UNITED STATES PATENT AND TRADEMARK OFFICE

Office Action Summary	Application No. 10/752,208	Applicant(s) SABO ET AL.	
	Examiner Philip Gabler	Art Unit 3637

DETAILED ACTION

Fox '127 Figures 1-4

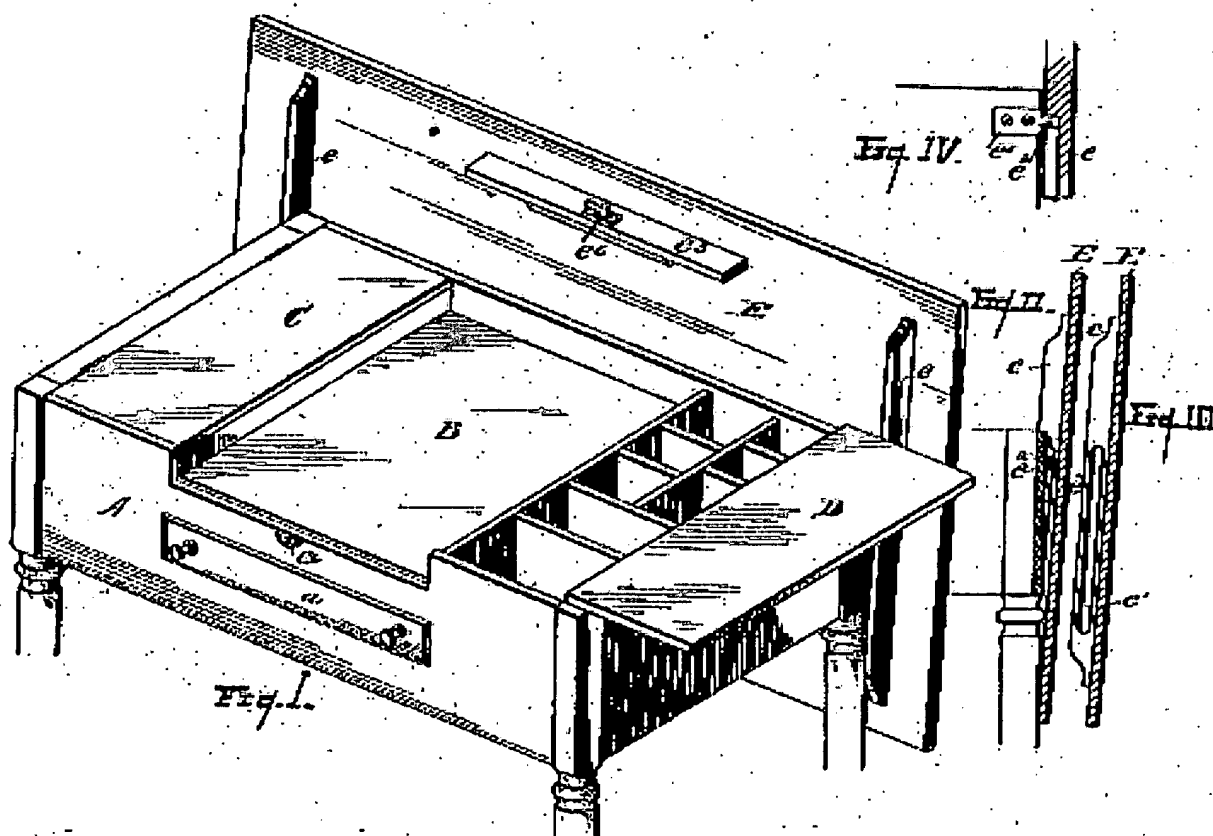
3. Claims 1, 3-9, 21-23, 25-31, and 33 are rejected under 35 U.S.C. 102(b) as being anticipated by Fox (US Patent Number 676127). Fox (Figures 1-4) discloses a storage container comprising: an enclosure (A) having an open top (at B and C), a bottom (lower portion of A), a first end and a second end (left and right sides of A, respectively) opposite the first end; a first lid (D) pivotally mounted to the first end, the first lid adapted to cover at least some of the open top; and at least one second lid (E) detachably mounted (would be removable with members e, e², etc.) between the first end and the

second end, the second lid adapted to cover at least some of the open top; and a third lid (also D) pivotally mounted to the second end, the third lid adapted to cover at least some of the open top; wherein the at least one second lid is slidably translatable along the open top of the enclosure between the first lid and the third lid (the lid is clearly slidable and at least portions of it can be between the first and third lids).

6. Regarding claim 5, Fox further discloses the first lid adaptable to be pivotally mounted into a horizontal position outside the open top of the enclosure (as shown by the right lid in Figure 1).

7. Regarding claim 6, Fox further discloses at least one of the first lid and the third lid is adapted to be pivotally mounted into a horizontal position outside the open top of the enclosure (see Figure 1).

11. Regarding claim 21, Fox further discloses the first lid comprises a through hole (viewed as the hole present on the lid mounted leaf of the hinge), and wherein the first lid is pivotally mounted to the first end by a hinge assembly (see left side of Figure 1) comprising: at least one hinge block (viewed as the enclosure mounted leaf of the hinge) having a through hole; and a circular rod adapted to engage the through hole in the block and lid, the circular rod having an axis (along its length); wherein the hinge assembly is adapted to allow rotation of the lid about the axis of the circular rod. [Note that Fox does not disclose specifics of his hinge; however, the members described above are viewed as inherently present in a standard hinge design. See for example US Patent Number 4099347 to Sharp, which discloses a typical hinge with two leaves, through holes, and a pin/rod.]

12. Regarding claims 22 and 23, Fox further discloses the hinge assembly is adapted to allow at least about 180 degrees of rotation of the first lid about the circular rod (see figures).

13. Regarding claims 25-28, Fox further discloses the storage container comprises means (legs of A, the upper portions of which contact the lids in their open positions) for supporting the first lid in an open, substantially horizontal position (as with the right lid in Figure 1), wherein the means for supporting the lid comprise a rod compression

member (the legs are viewed as rods and would be in compression under the weight of the container as well as lid).

14. Regarding claims 29 and 30, Fox further discloses at least two hinge blocks (see figures) and the first lid comprises a notch (viewed as the notch in the lid mounted leaf of the hinge), and wherein the at least one hinge block is adapted to engage the notch.

Tucker '353 Figures 1, 3, and 4

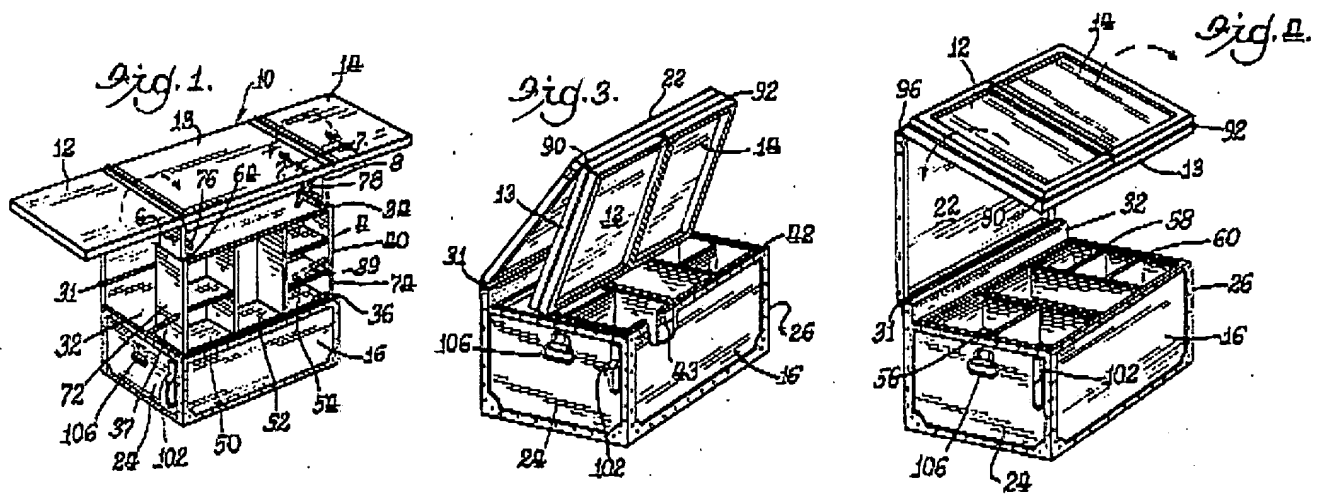
19. Regarding claim 10, Fox discloses a container as recited in claim 1 but does not disclose a plurality of second lids. Tucker (Figures 1, 3, and 4) discloses a storage container with a plurality of detachably mounted (via their hinges) second lids (12-14). Accordingly, it would have been obvious to one of ordinary skill in the art at the time the invention was made to incorporate a plurality of second lids as taught by Tucker in Fox's container because of the additional surface area this could provide while maintaining a compact arrangement when folded.

20. Regarding claim 32, Fox discloses a container as recited in claim 1 but does not disclose a liquid collector. Tucker discloses a storage container with a liquid collector (viewed as the recess in member 12, see Figure 4) in a second lid. Accordingly, it would have been obvious to one of ordinary skill in the art at the time the invention was made to incorporate a liquid collector as taught by Tucker in Fox's lid because this would help contain any items or liquids on the surface of the lid and help prevent them from falling off of the edge of the lid.
